VILLAGE OF ORLAND PARK

Meeting Agenda

[2020-0319](#) Orland Fire Protection District Maintenance Building - Development Petition for Site Plan, Elevations, Landscape Plan, Variances

File Number: **2020-0319**
 Orig. Department: **Development Services Department**
 File Name: **Orland Fire Protection District Maintenance Building - Development Petition for Site Plan, Elevations, Landscape Plan, Variances**

EXTERIOR MATERIAL COLOR EXHIBIT

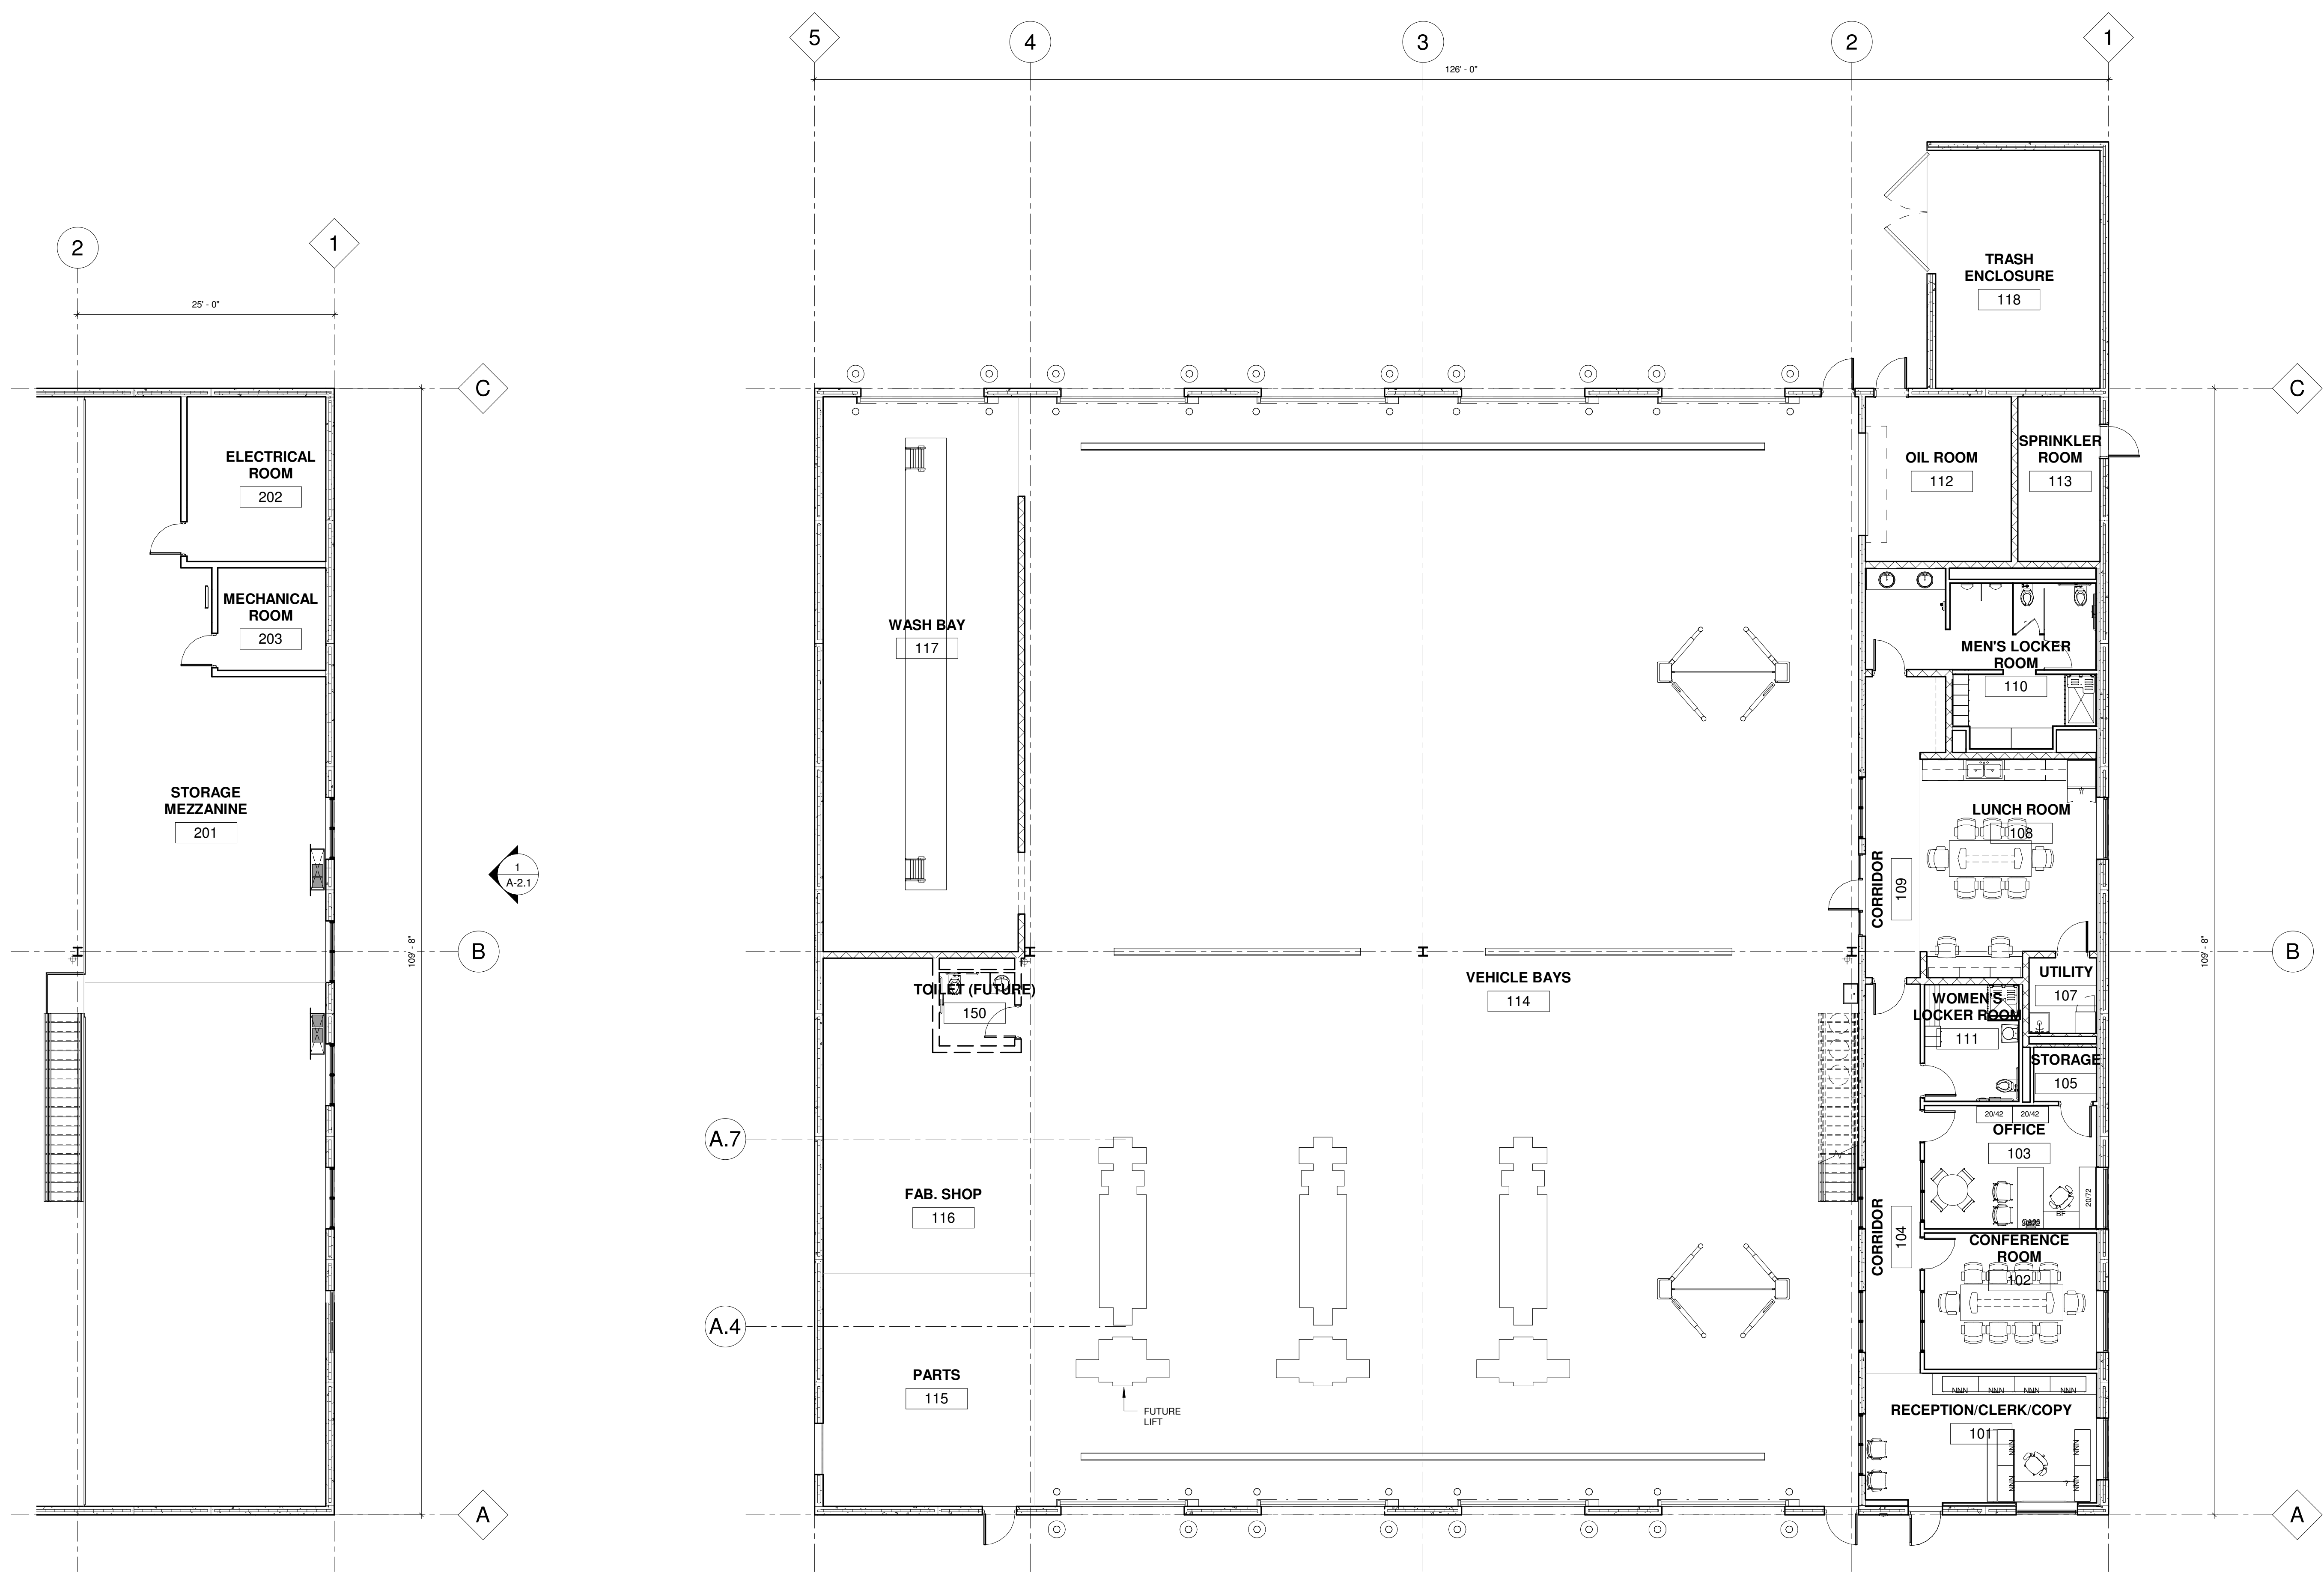
Per Section 6-308.F of the Land Development Code, painting masonry shall be allowed only through approval of an Appearance Review by the Development Services Department or through approval by the Plan Commission and Board of Trustees. Paint and painting procedure specifications are required to be submitted to the Development Services Department for review and approval prior to initiation of any masonry paint-related work.

A black steel framed awning canopy painted Tricorn Black - Sherwin Williams 6258 will be installed above four (4) of the vehicle bays. As shown on the submitted building elevations, a "future canopy extension" may be added above the right overhead garage door (vehicle wash bay) in the future. This canopy will match the design and color of the other black metal canopy on this elevation, and will be installed depending on the project budget.

I move to recommend to the Village Board approval of the **Elevations** titled “Elevations”, Sheets A-2.0 and A-2.1, and the “Exterior Material Color Exhibit”, prepared by Knight E/A, Inc., dated and last revised July 10, 2020, subject to the following conditions:

PROPOSED LANDSCAPE PLAN

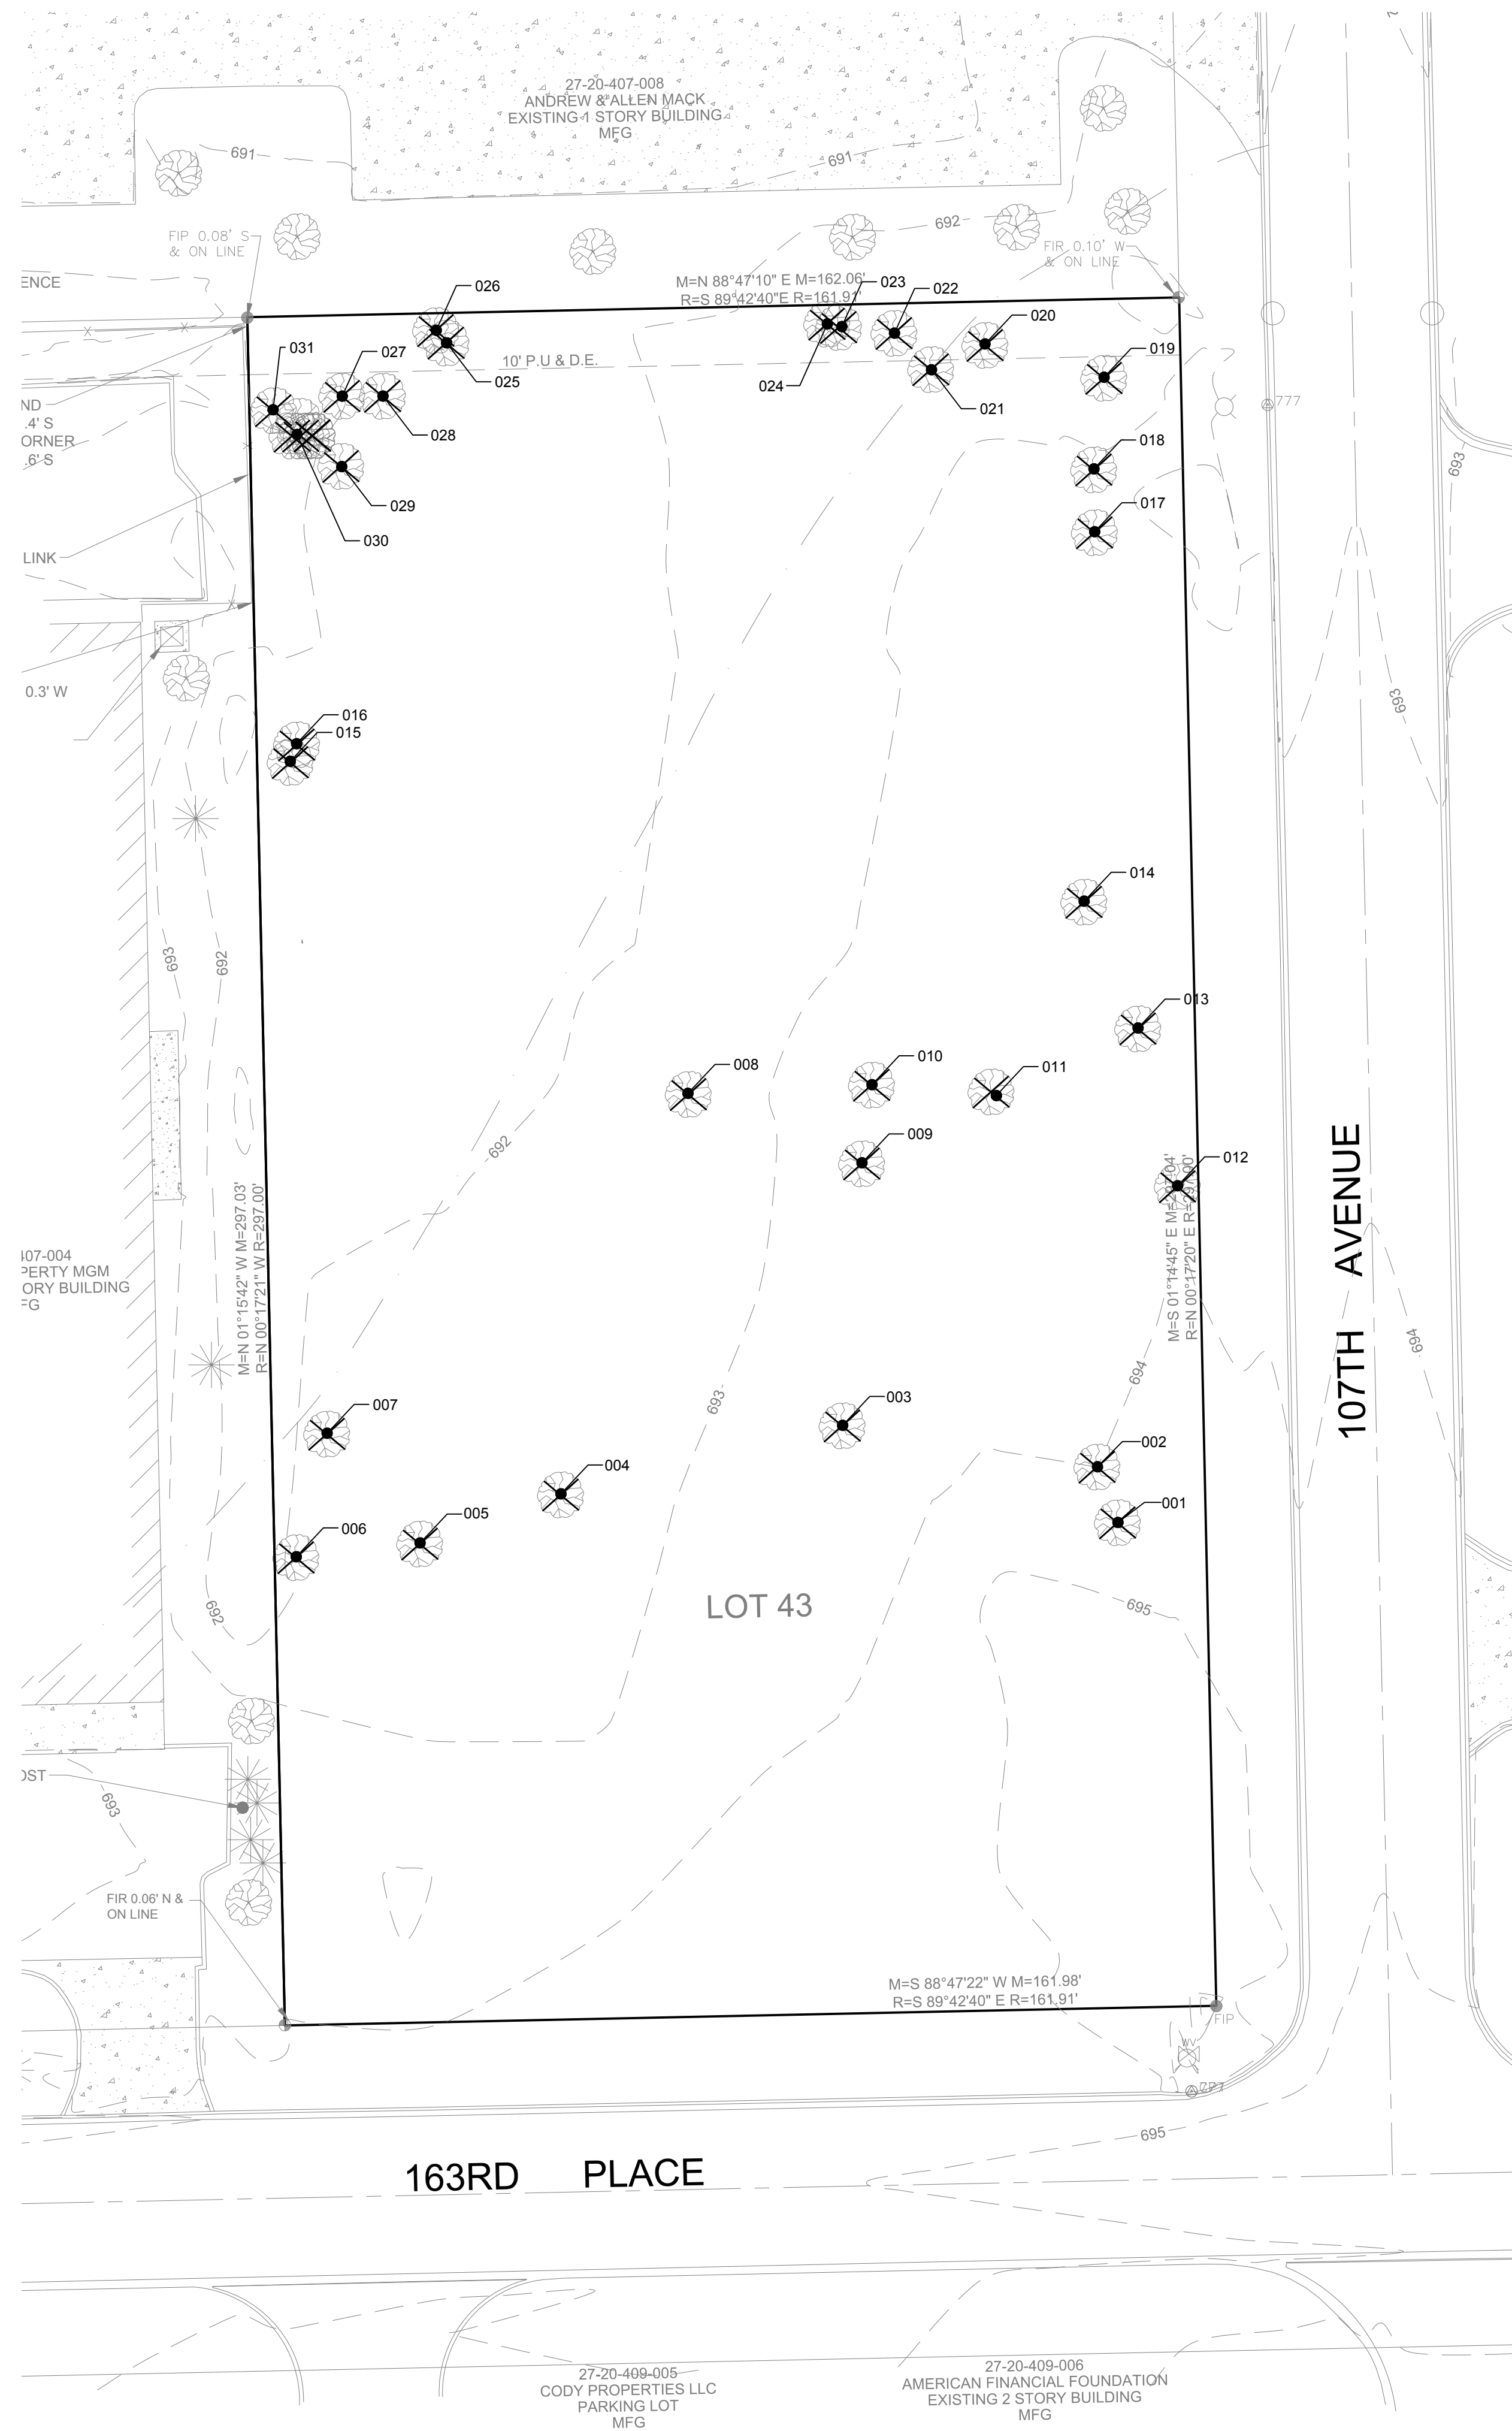
The preliminary landscape plan has been approved by the Village's landscape consultant. The petitioner must submit a final landscape plan for separate review in conjunction with final engineering. All

conditions included in the most recent comment letter must be addressed during final landscape plan review. It is imperative that the landscape design professional and project engineer coordinate their work to provide the grading required for landscape compliance.

The landscaping requirements for Landscape Parkways, Landscape Corridors, Landscape Bufferyards, Foundation and Interior Landscape, and Parking Lot Area Landscape have been met and will be confirmed during final landscape plan review. As shown on the submitted landscape plan, parkway trees will be provided along 163rd Place and 107th Avenue. Landscaping is provided along the north and west sides of the site to provide a buffer between adjacent land uses.

I move to recommend to the Village Board of Trustees approval of the **Preliminary Landscape Plan**, titled “Proposed Landscape Plan” and “Tree Preservation Plan”, prepared by Knight E/A, Inc., Sheets LP-1.0 and LP-2.0, dated and last revised July 10, 2020, subject to the following conditions:

1. Submit a final landscape plan meeting all Village Codes and all required supporting documentation addressing all outstanding landscape items in conjunction with the final engineering submittal.
2. Meet all tree mitigation and tree preservation requirements per Section 6-305.F. The petitioner shall be required to pay cash in lieu of tree mitigation, as determined during the final landscape plan review process.
